**IFB ADDENDUM # 2**

**IFB No. 20-003-20**

**Material and/or Service: Andrada Polytechnic High School Presentation Hall Building Addition**

**ADDENDUM NO: 2**

**e2.1**

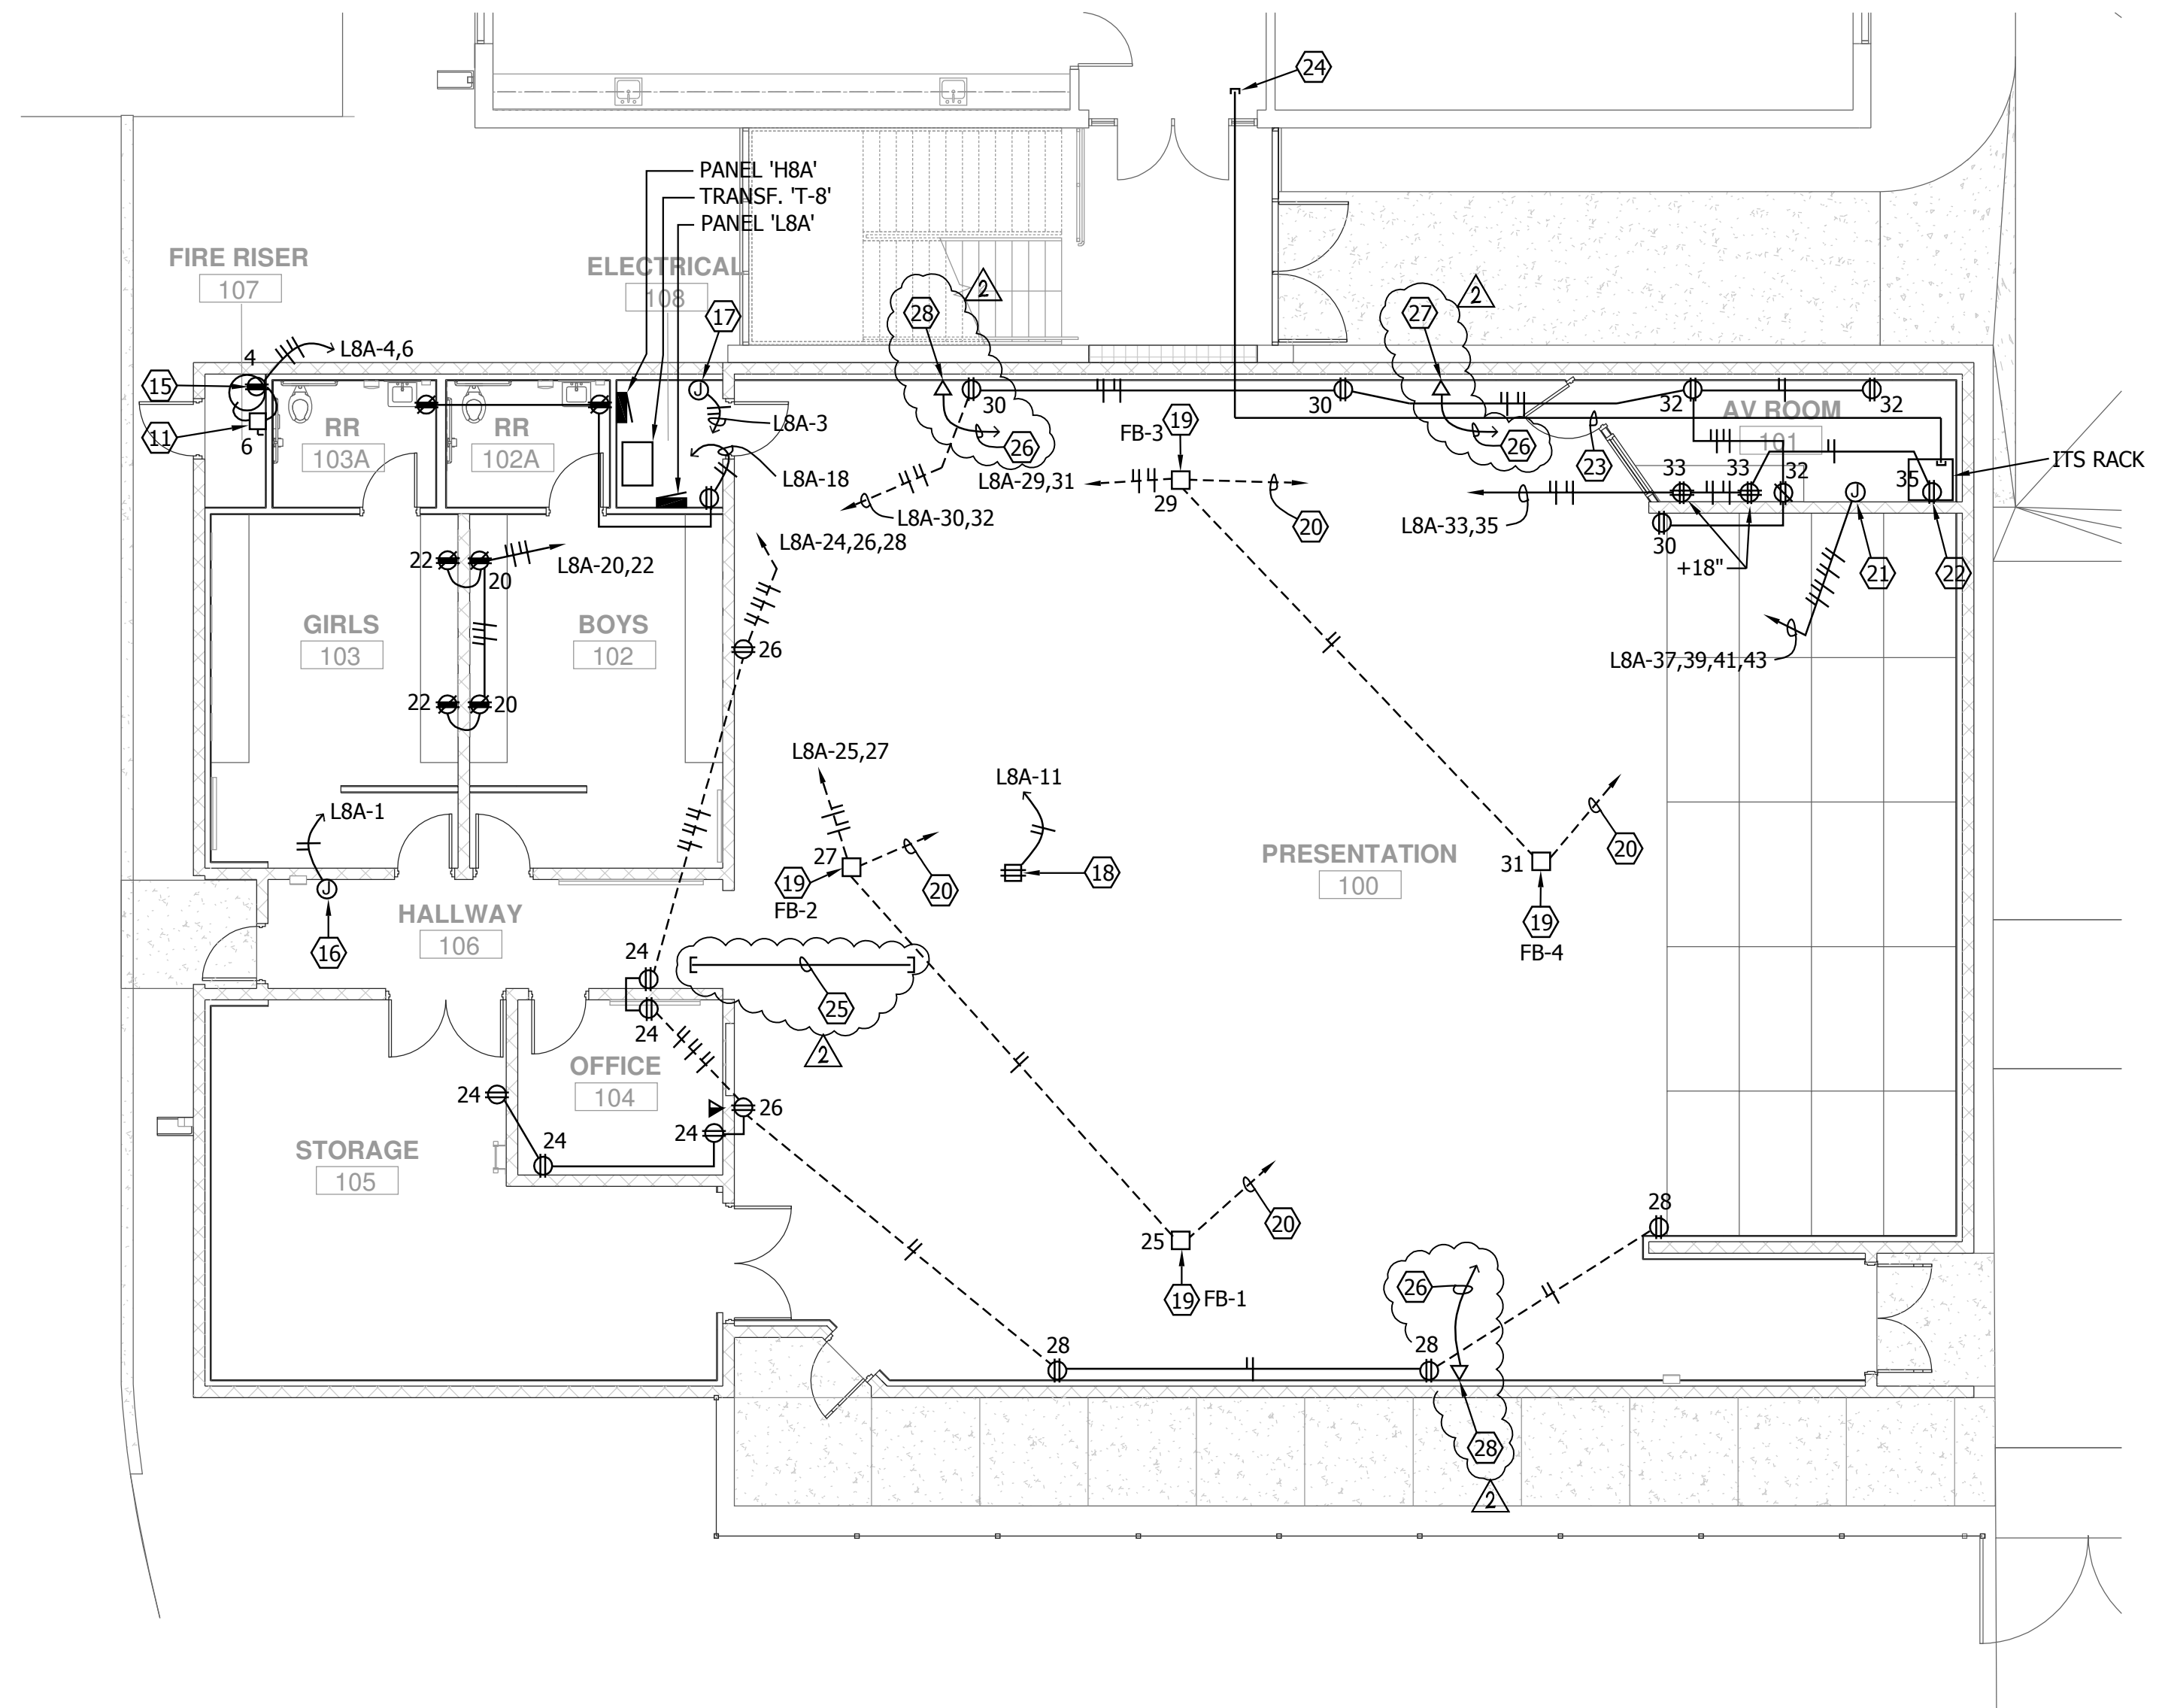
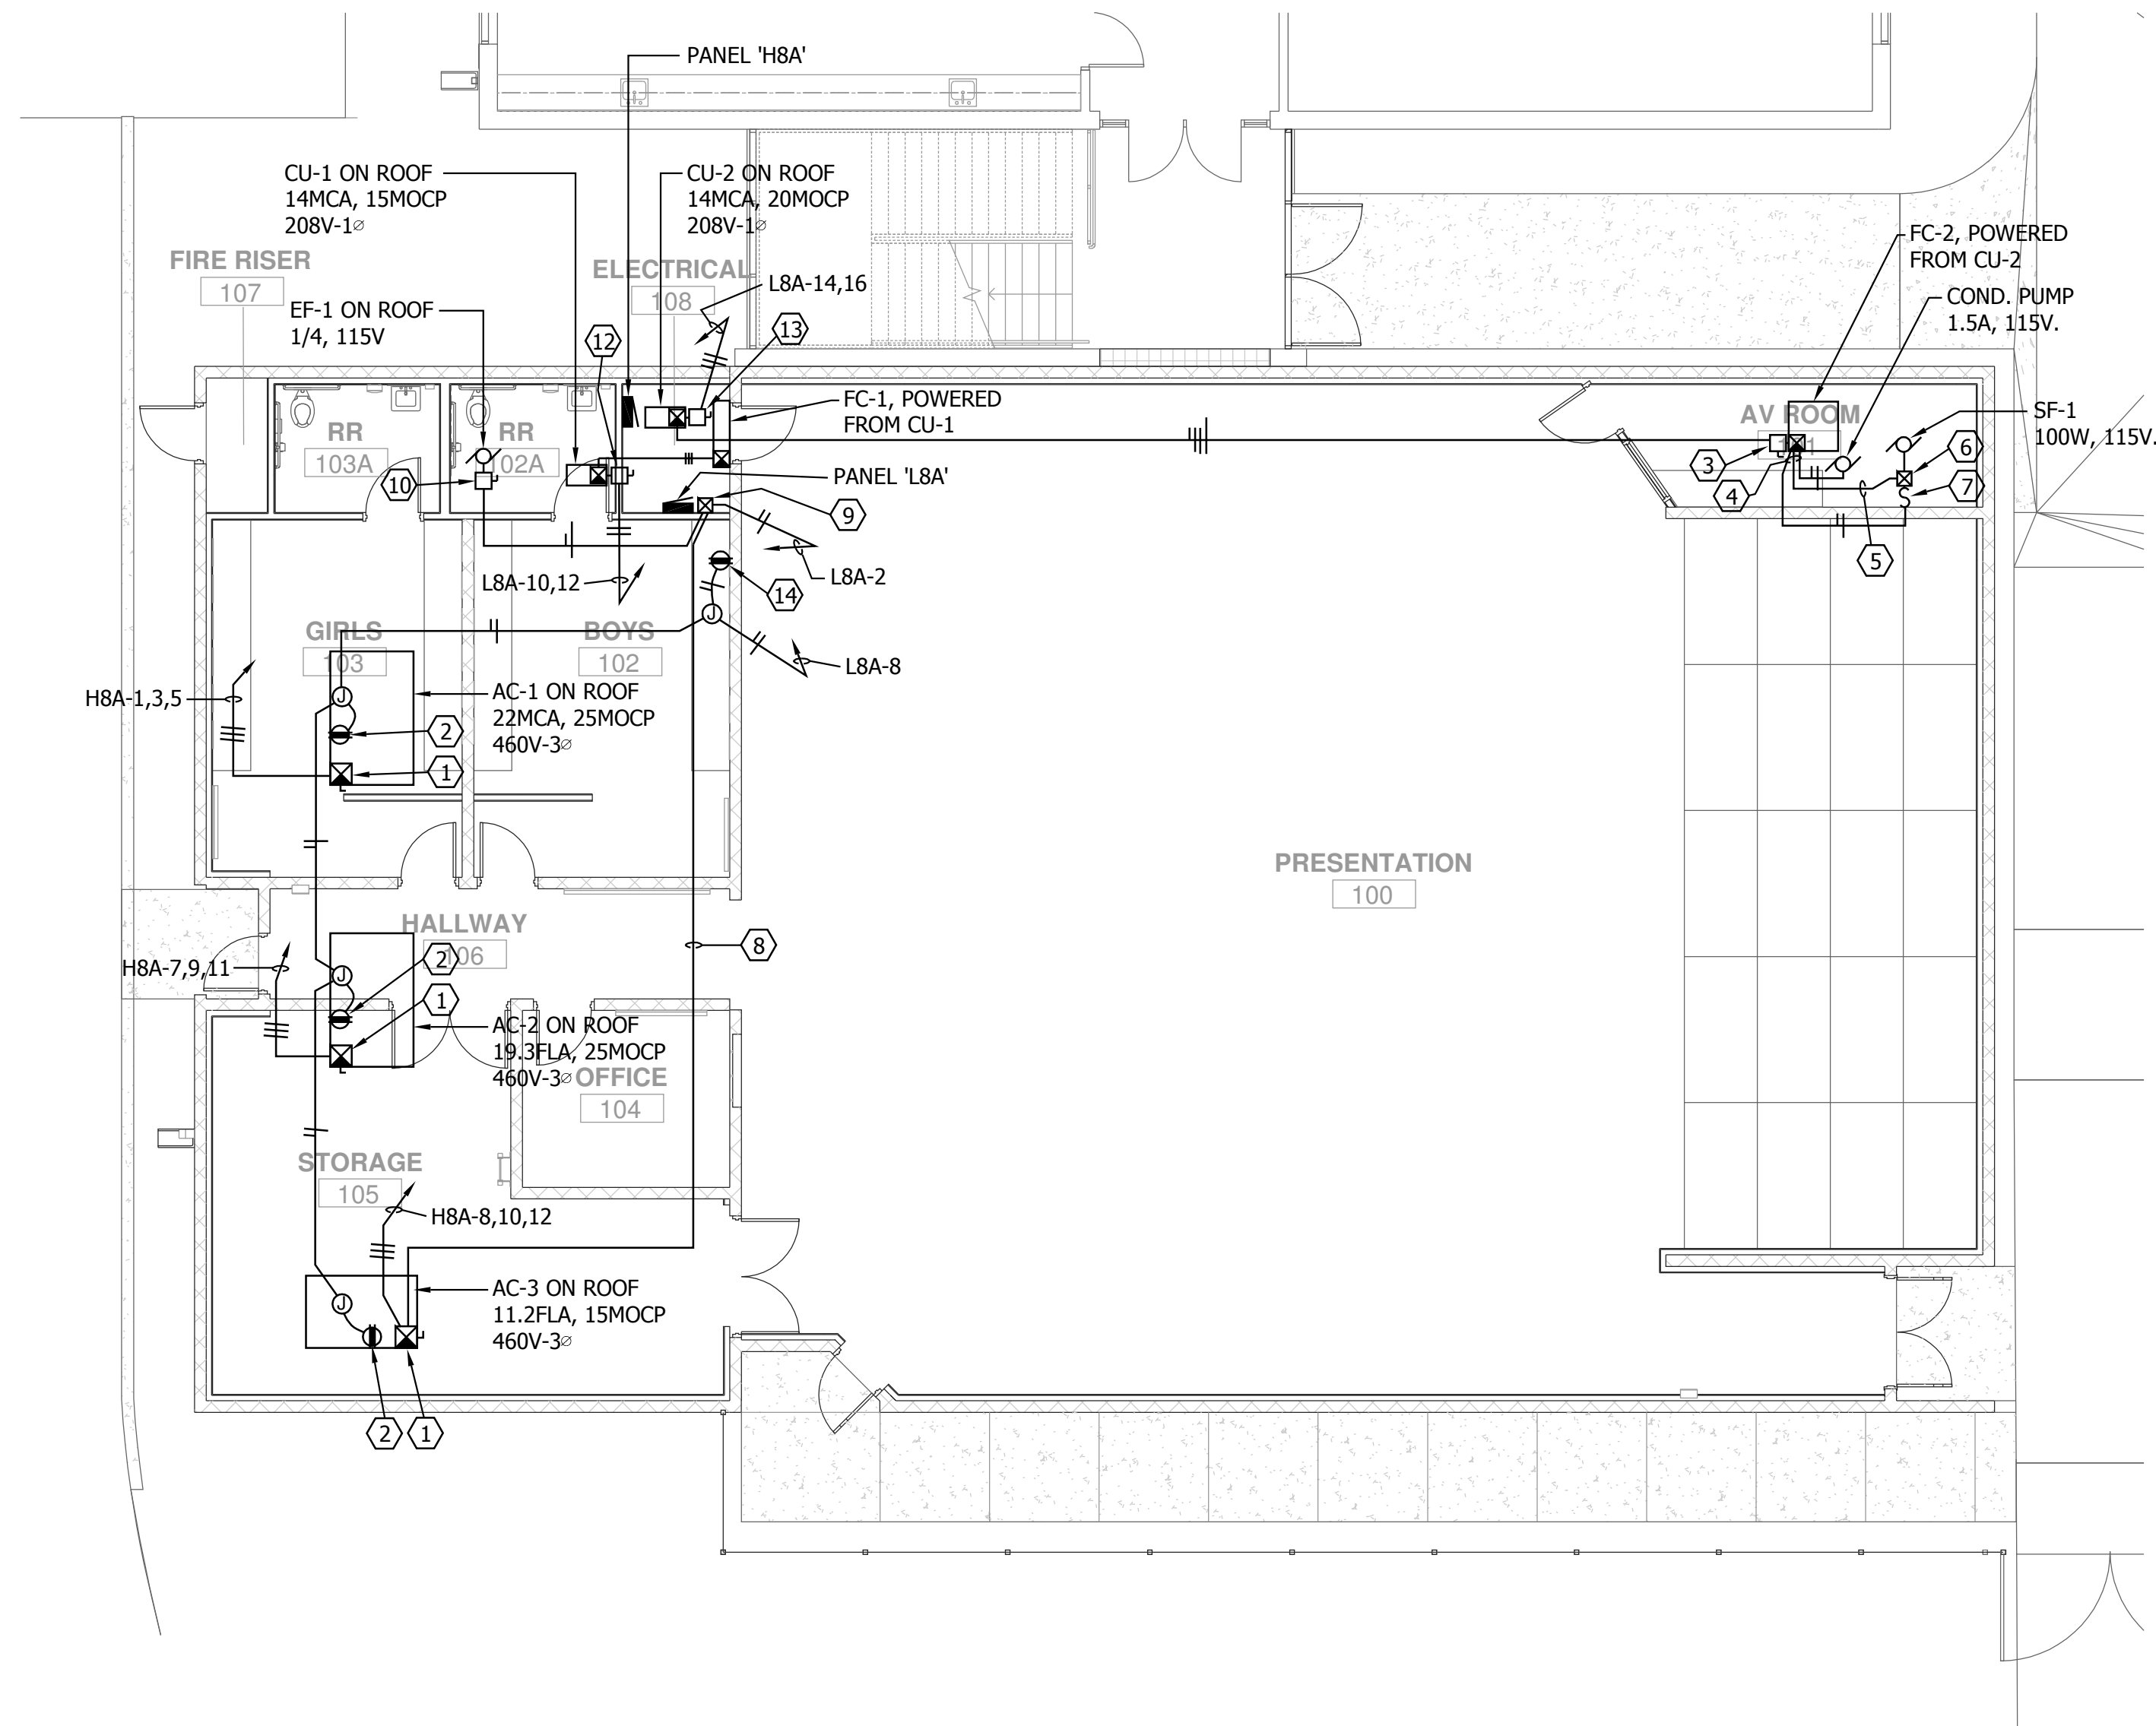
- ITEM 7** Sheet e2.1, Power Plan:  
Updated sheet attached. This version supersedes the sheet issued in addendum #1.
- ITEM 8** Drawings, Sheet t2.0, IT Plan:  
Refer to AV and E sheets for proper location of projector.
